FORM APPROVED
OMB NO. 1004-0137
Expires: January 31, 2018**SUNDRY NOTICES AND REPORTS ON WELLS**
Do not use this form for proposals to drill or to re-enter an abandoned well. Use form 3160-3 (APD) for such proposals.

Trigg Federal Gas Com #1

30-015-20159

Trigg Federal Gas Com #1

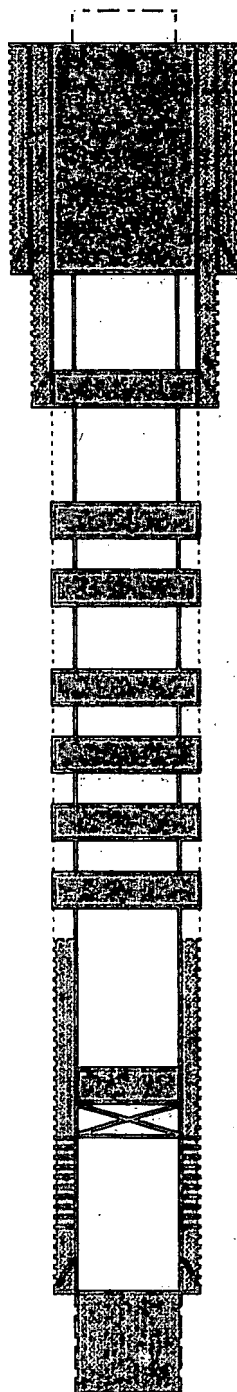
GC 4/15/19
Accepted for record - NMOCAll Perfs Require
Tags.SEE ATTACHED FOR
CONDITIONS OF APPROVAL
